MIL-PRF-83536/9
AMENDMENT 3
10 July 1999
SUPERSEDING
AMENDMENT 2
29 March 1996

PERFORMANCE SPECIFICATION SHEET

RELAYS, ELECTROMAGNETIC, ESTABLISHED RELIABILITY, DPDT,
LOW LEVEL TO 10 AMPERES, PERMANENT MAGNET DRIVE,
HERMETICALLY SEALED, ALL WELDED, DC COILS

This amendment forms a part of MIL-PRF-83536/9, dated 27 March 1992, and is approved for use by all Departments and Agencies of the Department of Defense.

SOCKET PIN

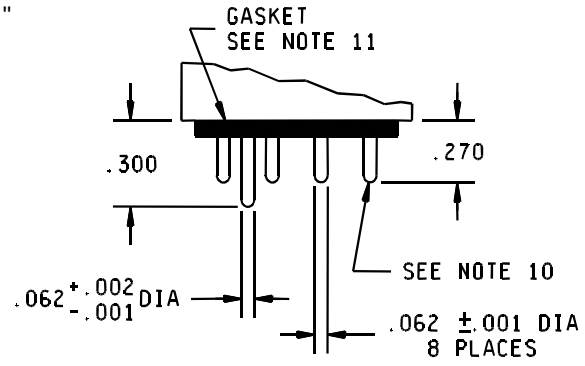
FIGURE 1, socket pin diagram, delete and substitute:
